DATE: May 15, 2009

Addenda No. 3

SUBJECT: I-205: Glenn Jackson#09555 & Geo Abernethy#9403 Brs Project
East Portland Freeway
Multnomah, Clackamas, & Clark Counties
Structures Project
(Bids to be opened and read May 21, 2009)

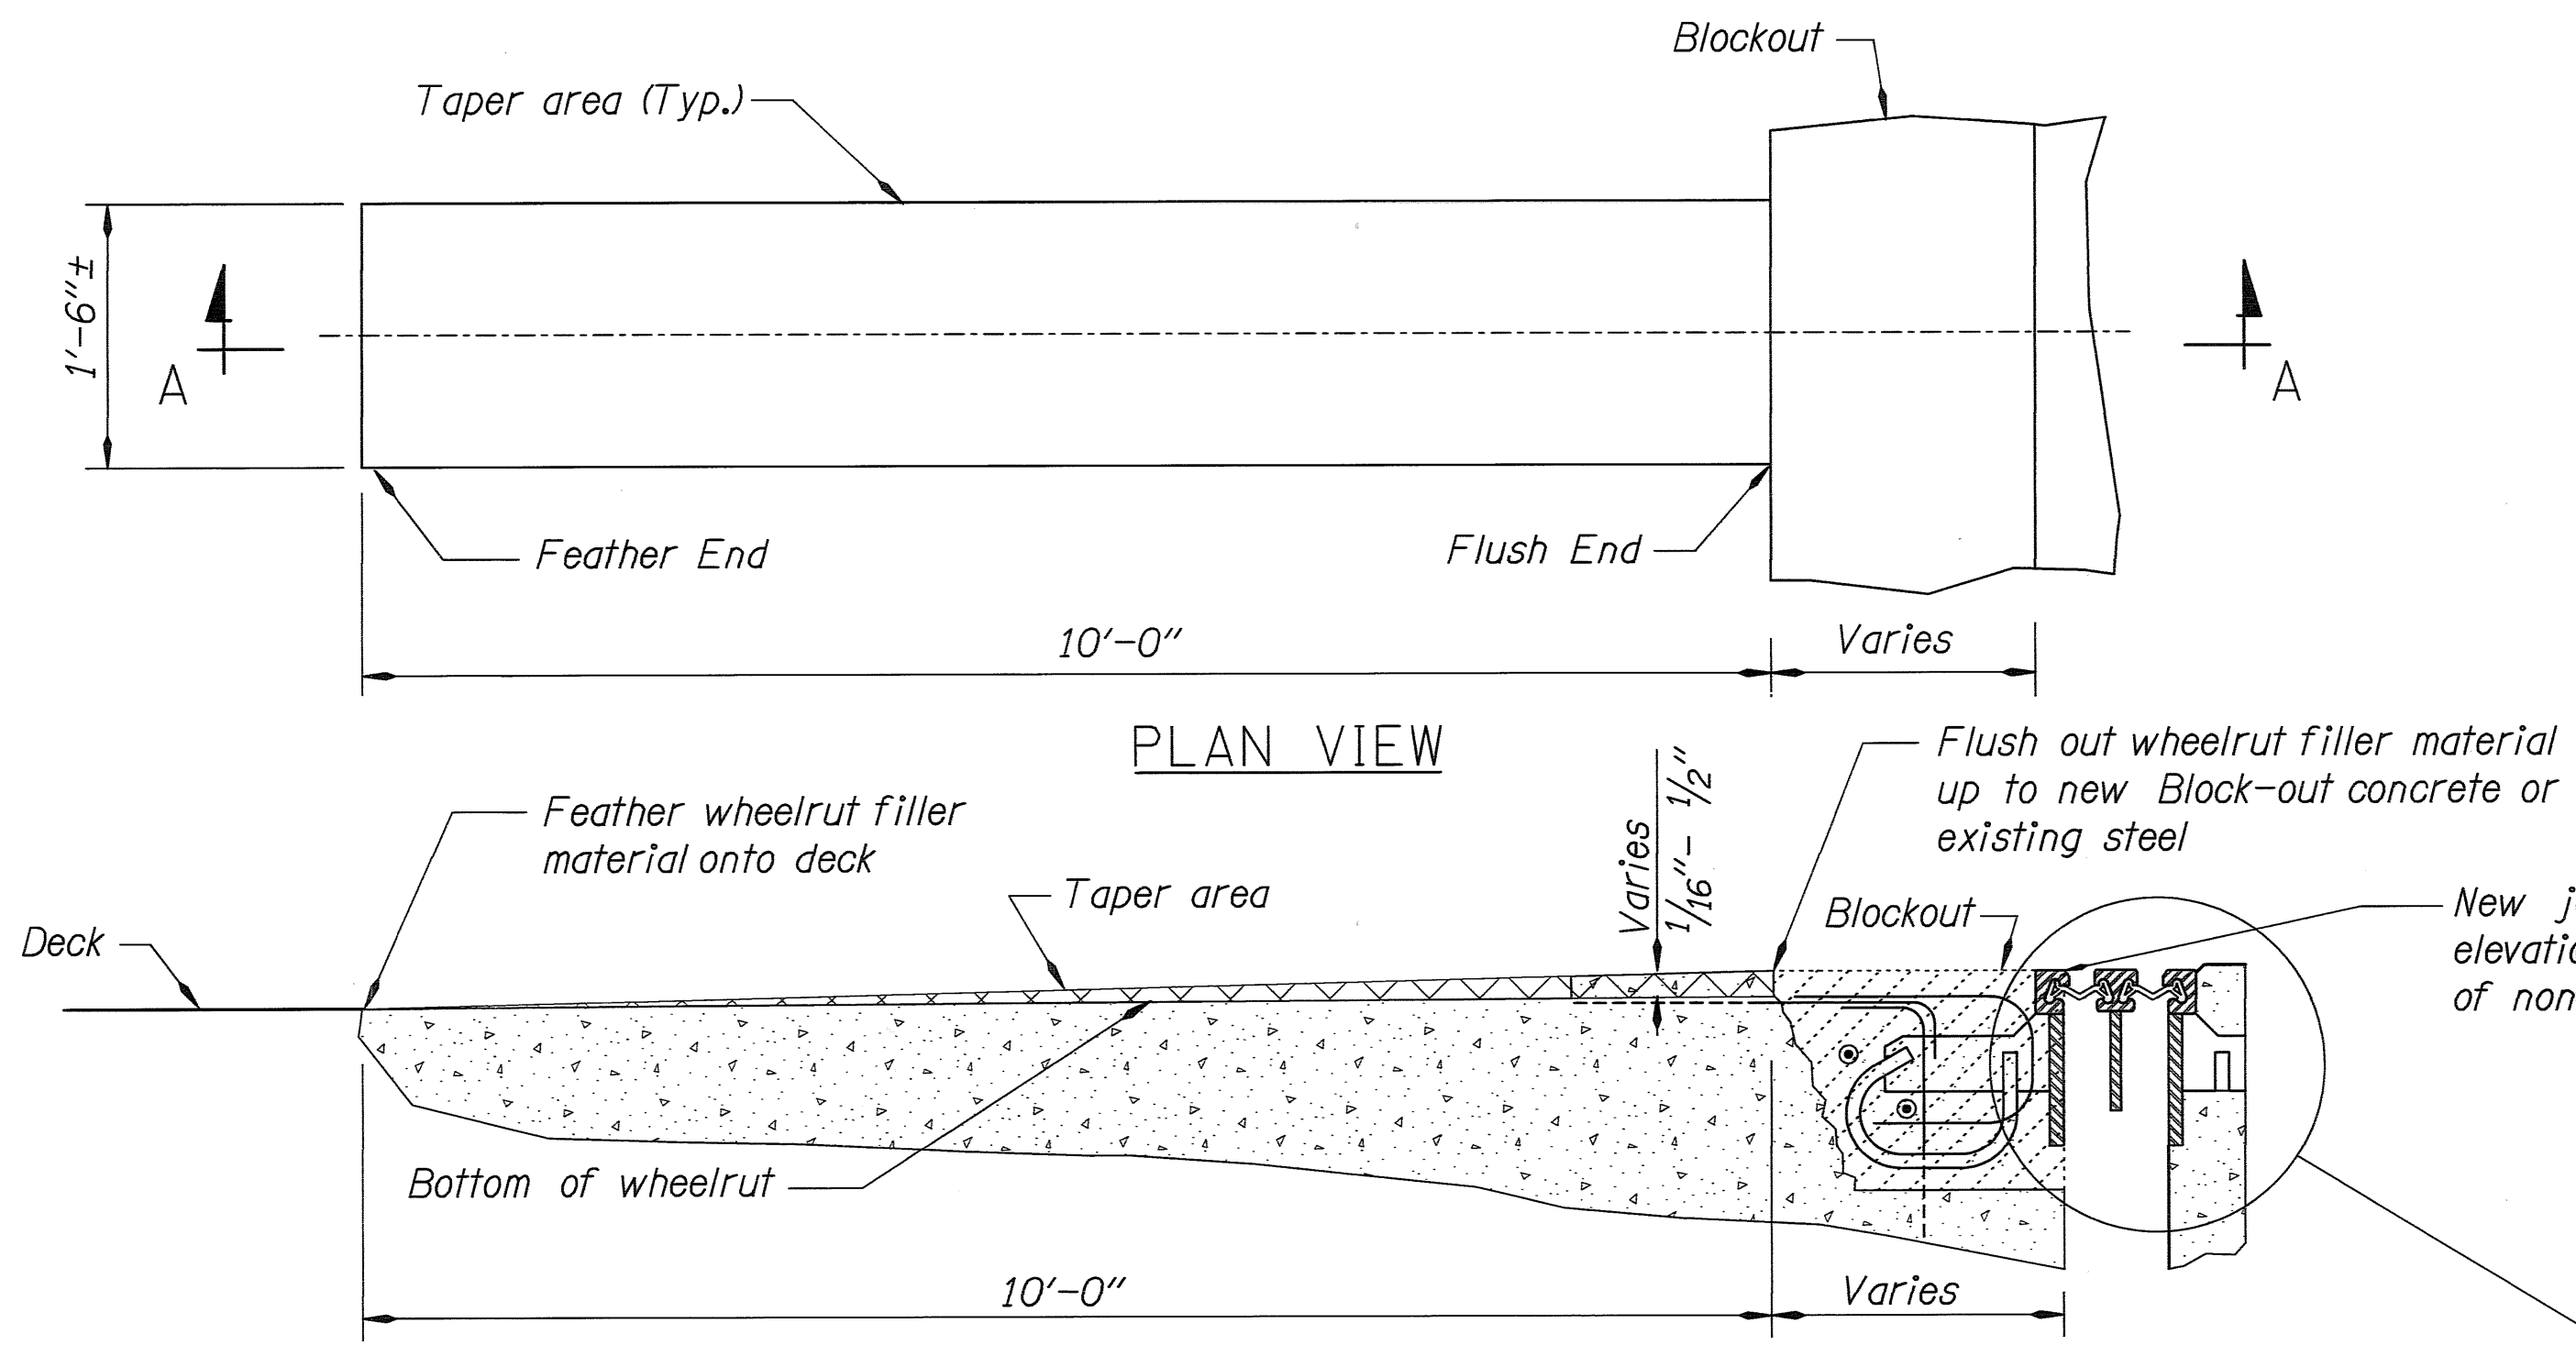
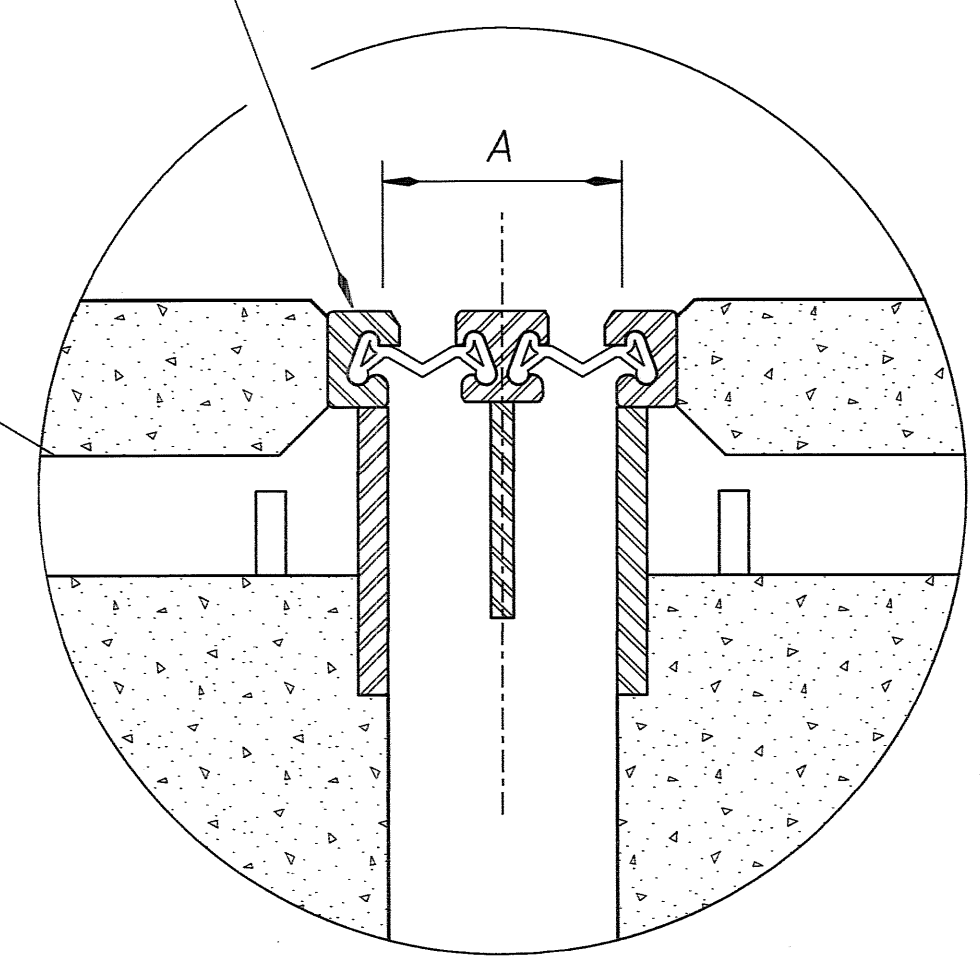
1. Plan sheet 80664 is replaced with revised plan sheet 80664.
